**FUNDING REQUEST FOR THE
TOWN OF STEVENSVILLE WATER REHABILITATION PROJECT**

Re: Sanitary Survey Inspection of Stevensville public water system (PWSID: #MT0000335).

STEVENSVILLE, TOWN OF 11 FWSID #MT00003335

inspected 6/25/2008 by Mike Kropp, DEQ PWS

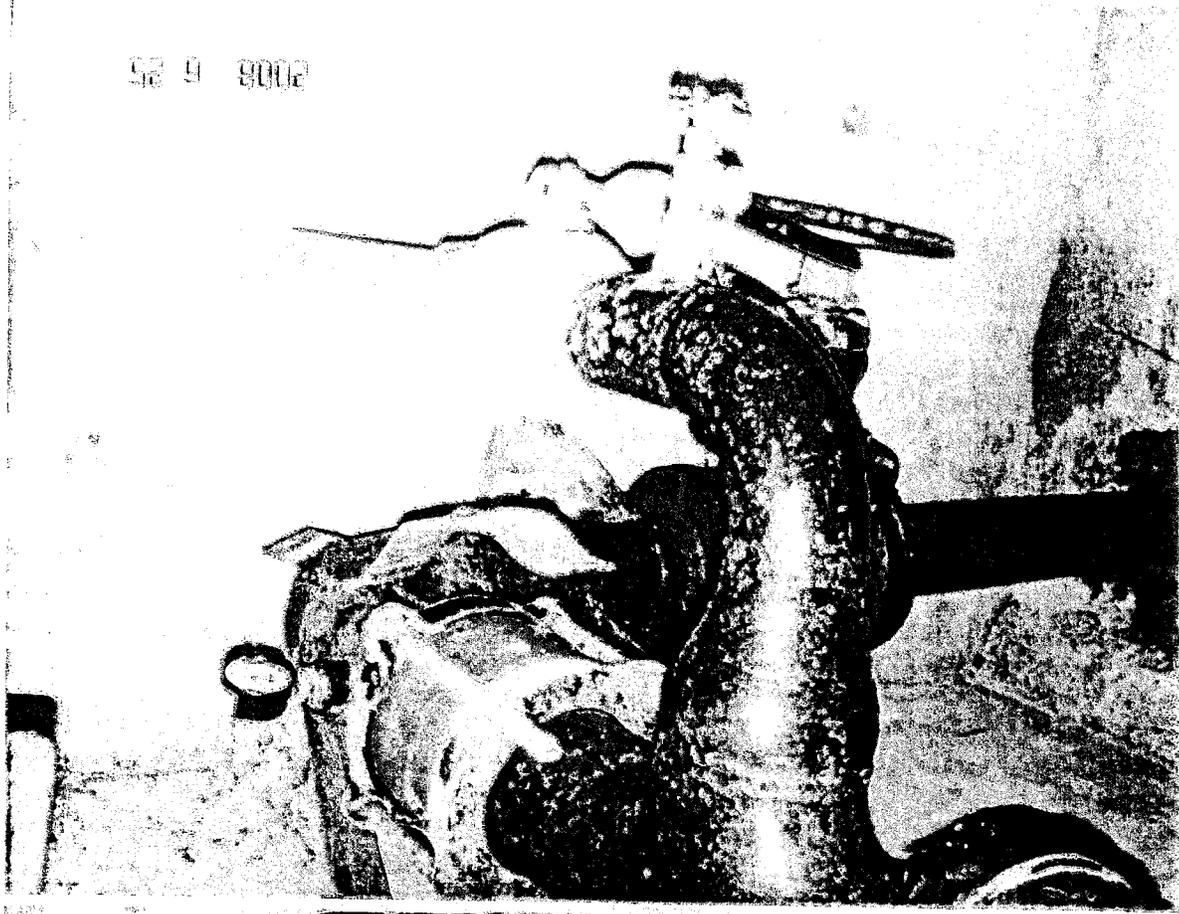
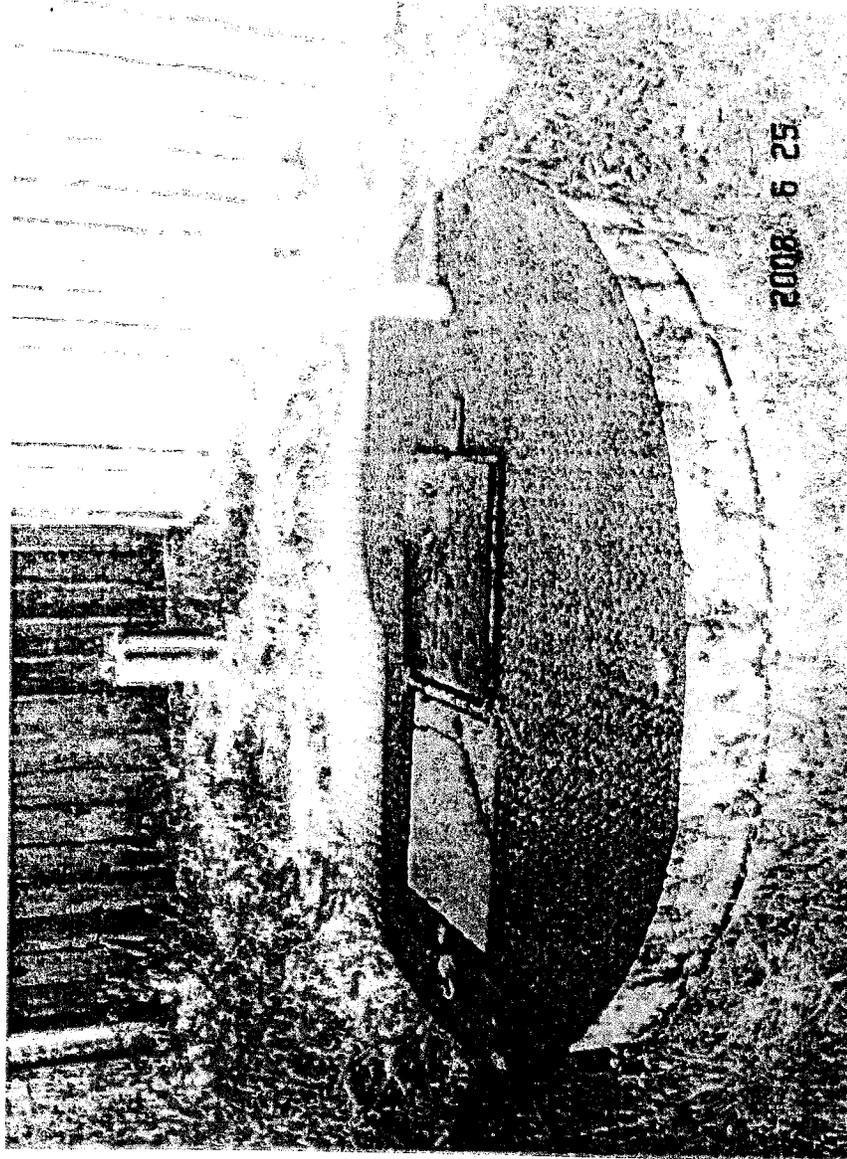
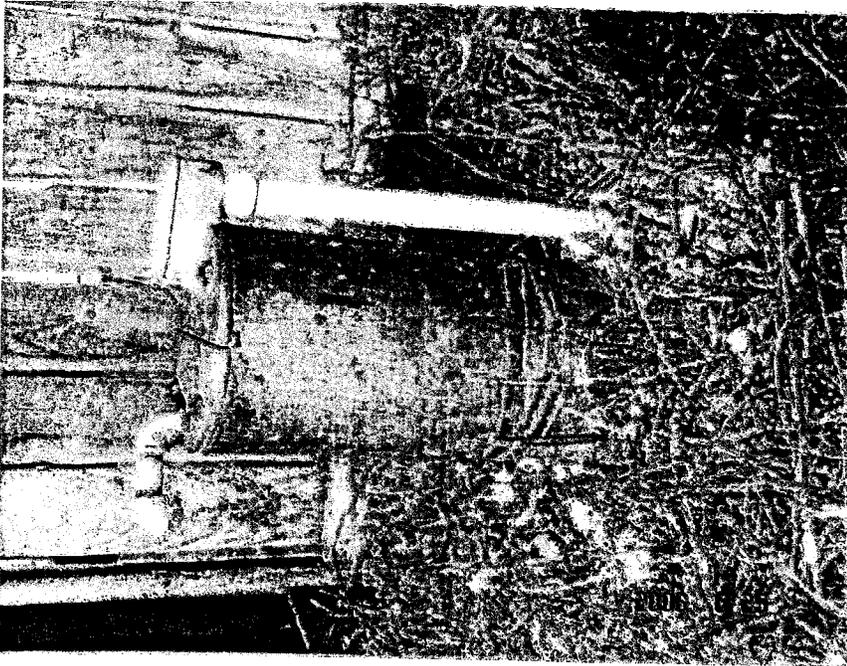
The pictures on this page show the remaining components in the well 2 (WL004) vault.

Top left: The wellhead is vented, but it terminates below the vaults flood rim along with an additional electrical box. The ladder is not permanently fixed to the side wall. The access hatch is not properly gasketed.

Top right: Well 2 (WL004) entry point to distribution can be seen running into the vault floor. A 2" blow-off pipe extends through the wall and terminates in a nearby ditch. This blow-off outlet is currently capped.

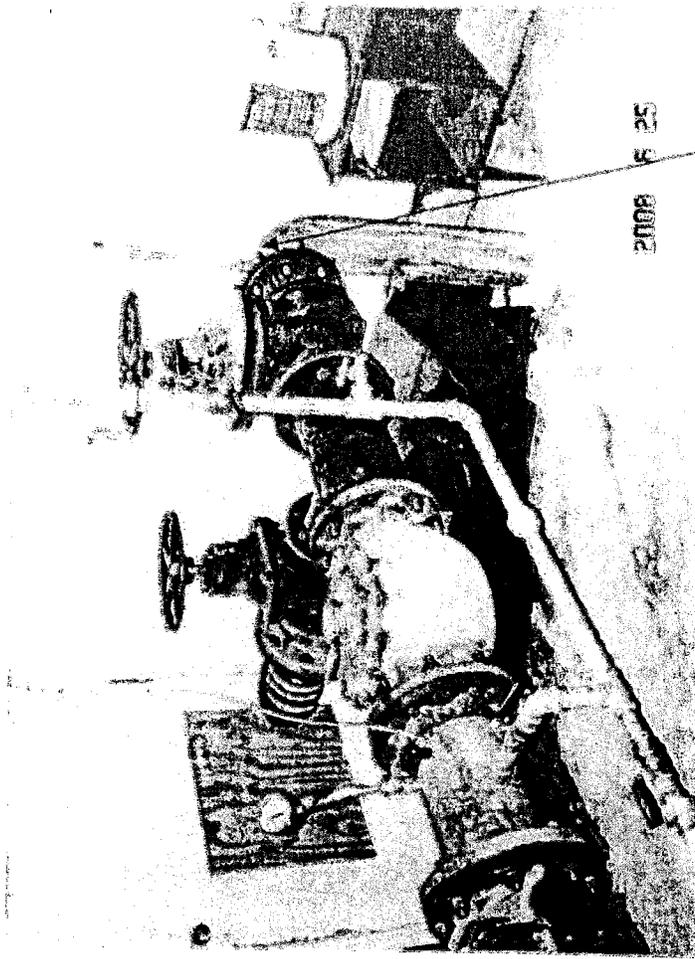
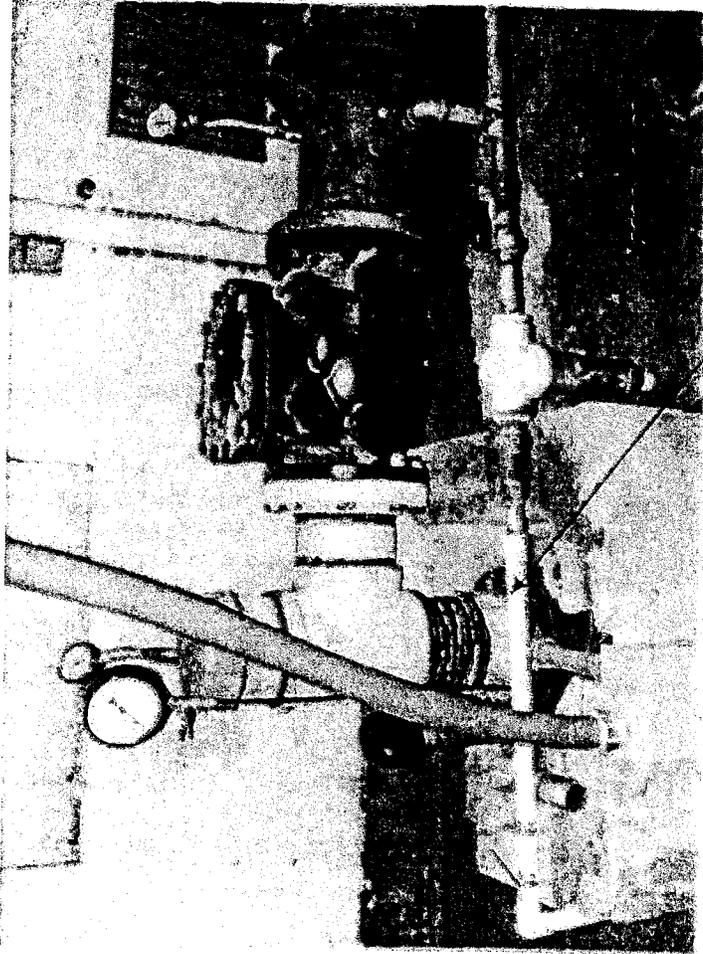
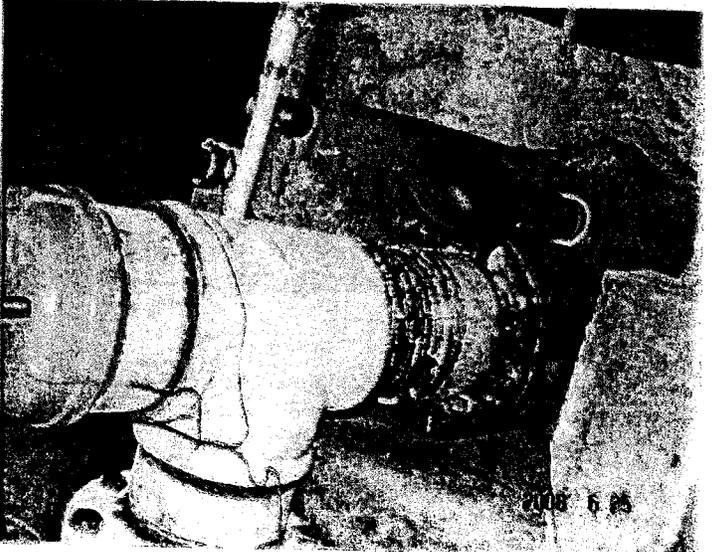
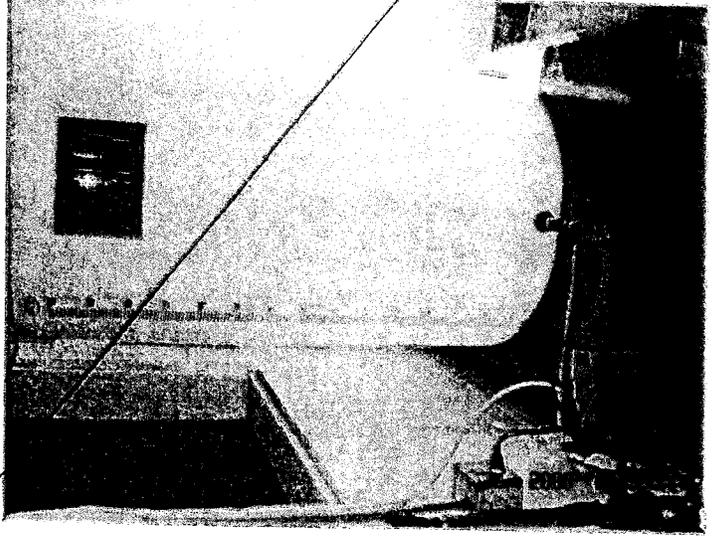
Upper left: Well 3 (WL005) wellhead. Split cap for outside use not recommended. Vent is screened. Well 3 is surrounded by homes.

Upper right: Well 3 control vault.

Lower left: Inside well 3 vault. Garbage in vault with some sign of high water. Not a permanent affixed ladder.

Lower right: Well 3 control panel +/- 10' from control vault.

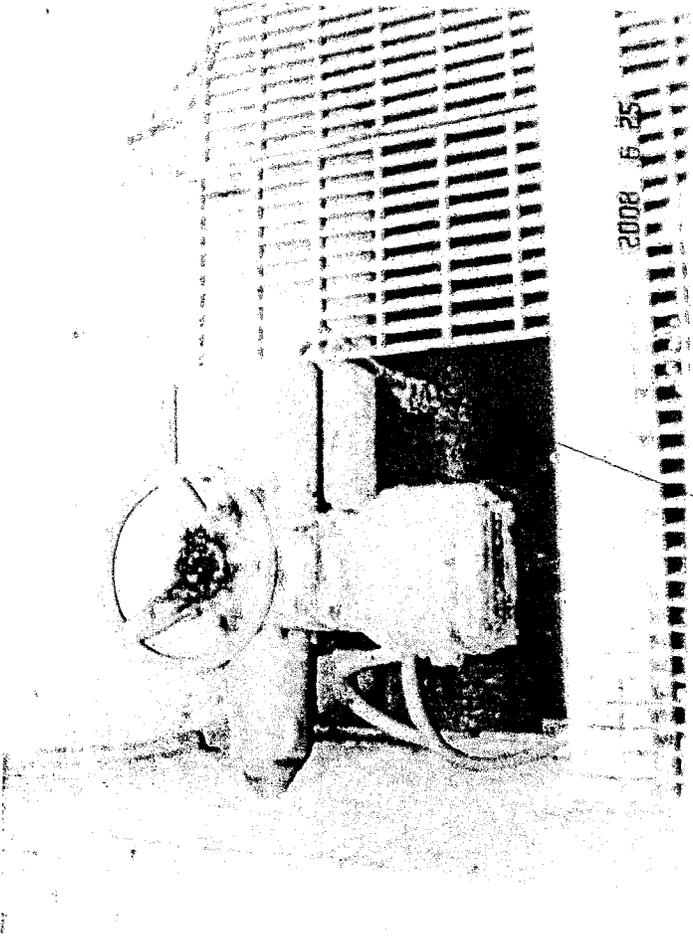
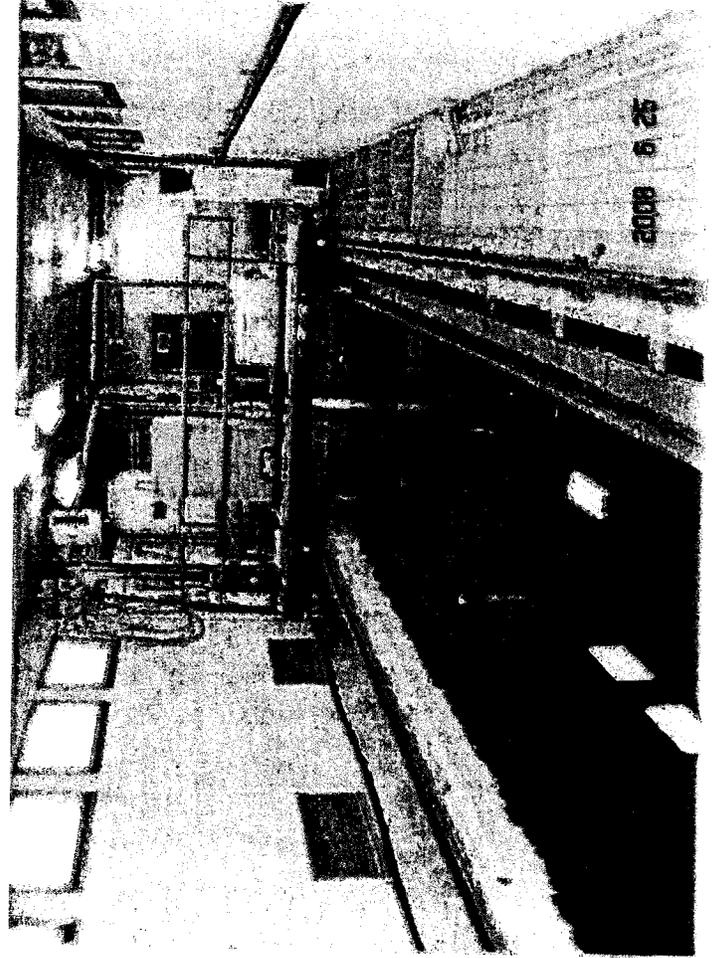
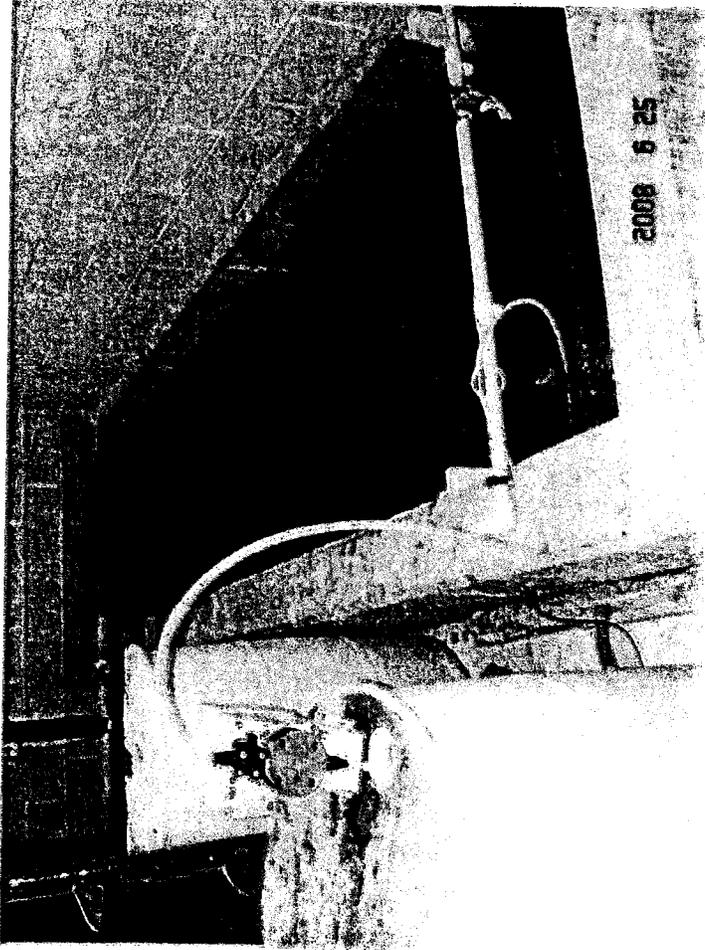
Well 1 (WL003) pictures are shown this page with orthophosphate treatment. (No disinfection in place @ WL003). Injection point for TP002. This well has VFD controls but is set to operate like a standard motor. I can only assume it was installed to minimize hammer at start and stop because VFD used in conjunction with storage tank float controls doesn't seem to be overly beneficial. PVC line goes to spigot. I recommended the operator write the length of the sounding tube on the face of the pressure gauge for easy reference when using the depth gauge set up. The fire hose is used for blow-off purposes.

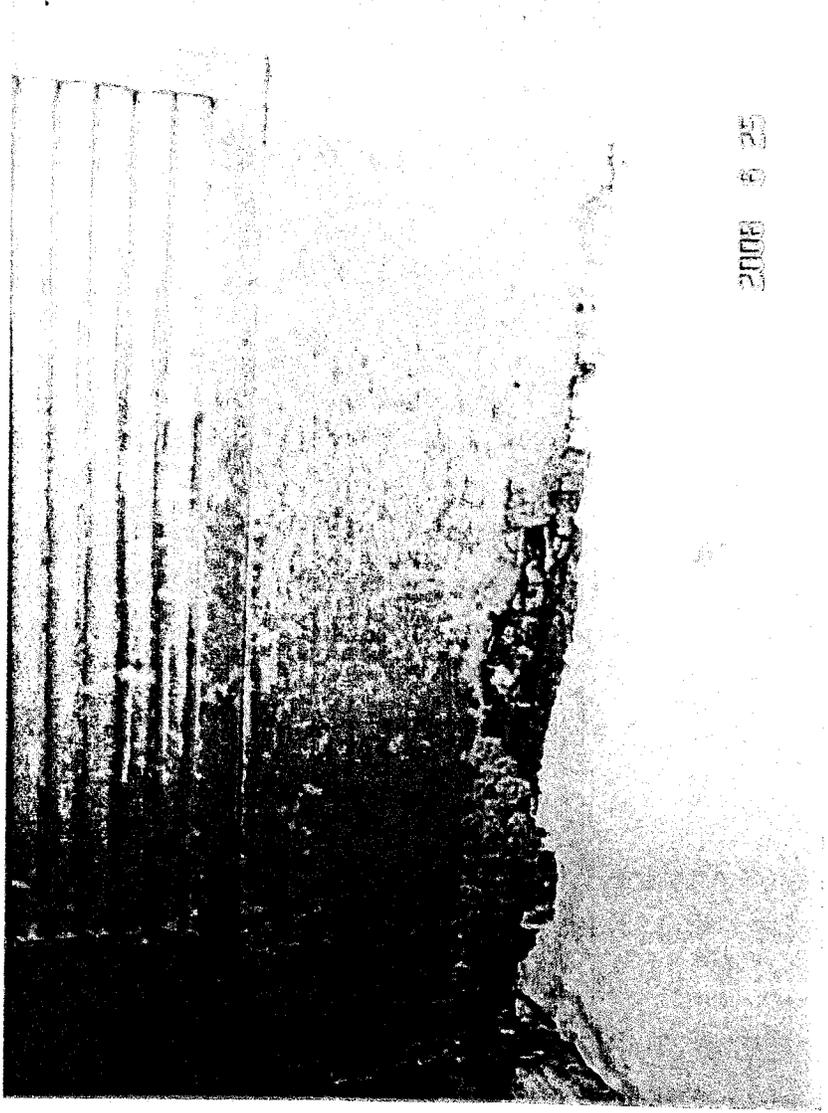
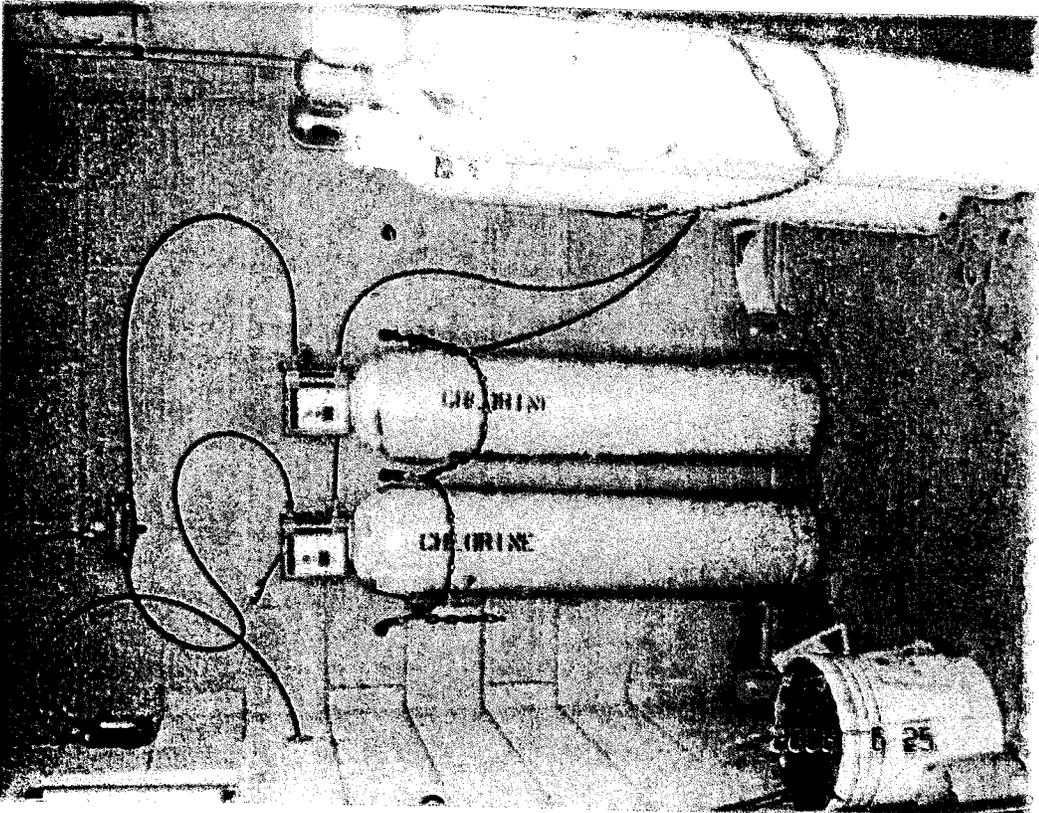
Top left: Surface water inlet from Swamp Creek and Mill Creek sources (TP001). Excess water flows over a wall at the far end of the entry basin and goes to storm drain. Coagulant (alum) is added and flows through settling basin. Chlorine injection is available at this point, but is not used.

Lower left: The sand filter bed can be seen. Chlorine injection point is at the far left side of the picture as the filtered water goes to the 500,000 gallon storage tank (ST001).

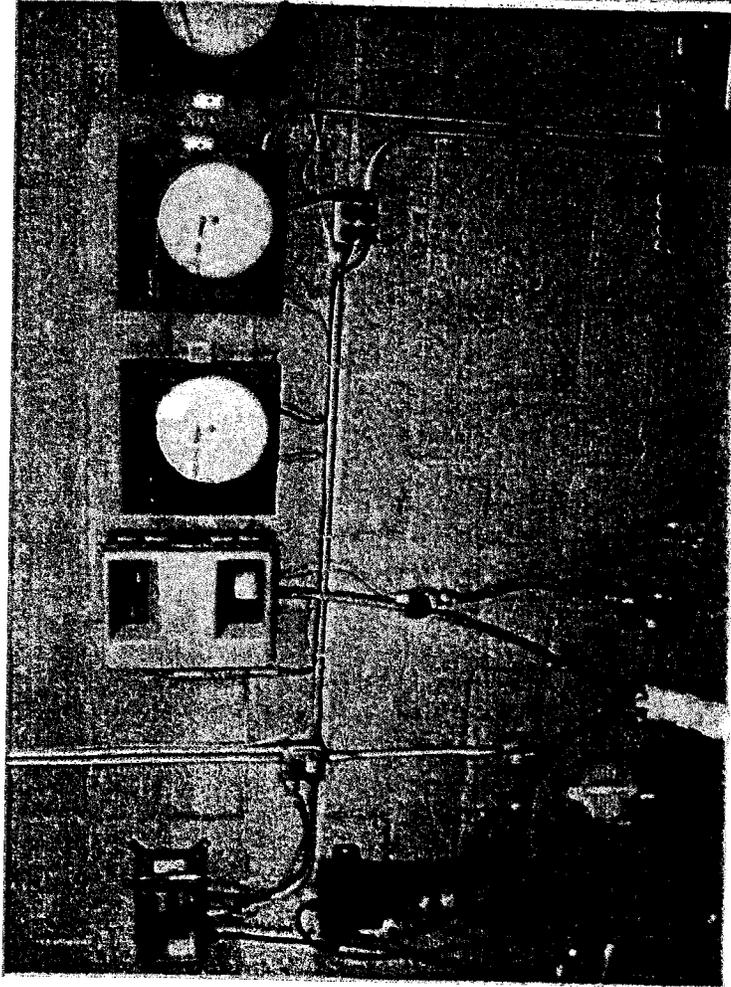
Stevensville uses gas chlorination at T001 (surface water plant). Deficiencies include no panic bar on door, no scale under tanks in use and vent outlet doesn't open with exhaust fan operation. Accumulation of chlorine gas at floor level has eaten the bottom of the door up.

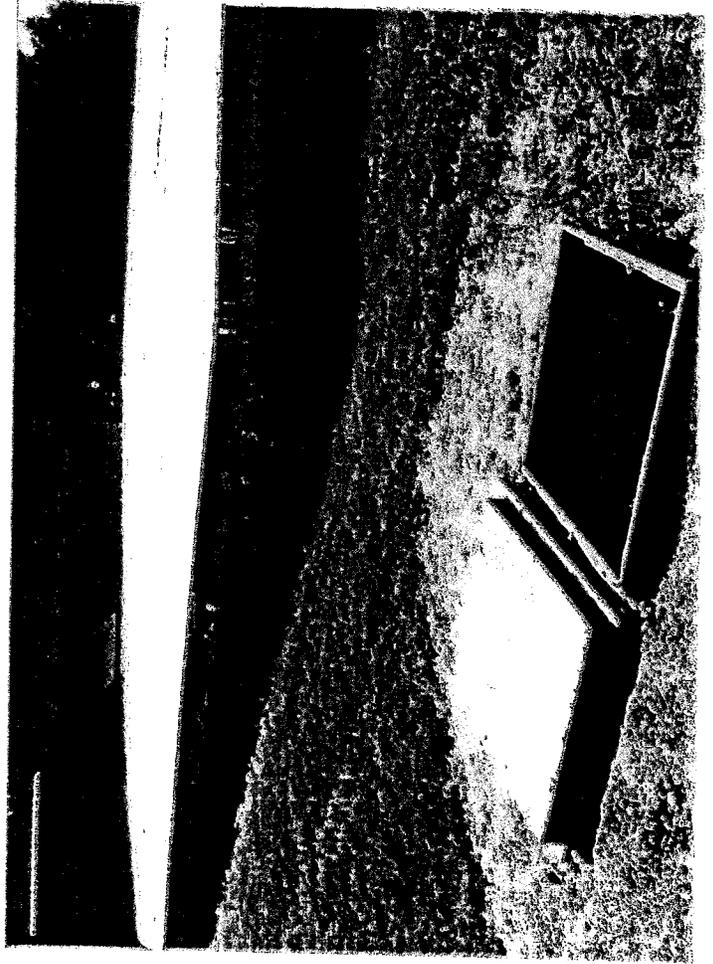
Top left: Top of 500,000 gallon storage tank (ST001) looking toward the surface water treatment building (TP001). The small shed located between TP001 and ST001 houses the automatic bypass valve if turbidity levels exceed acceptable levels leaving the plant.

Top right: Top of the storage tank with the facility roof vent shown in the front of picture. Vent was screened.

Bottom left: TP001, bypass structure, ST001 and a meter vault where a chlorine booster pump injects water leaving ST001 as it enters distribution.

NOTE: System doesn't know for sure where the bypass or ST001 overflow outlets are located, or if they're screened.

Top left: Existing 500,000 gallon storage tank (ST001) to the left – old storage tank structure that is now used for wastewater disposal near far fence – framed metal siding is used for lid to meter vault that also has a post storage chlorine injector and sump pump to keep ground water below components.
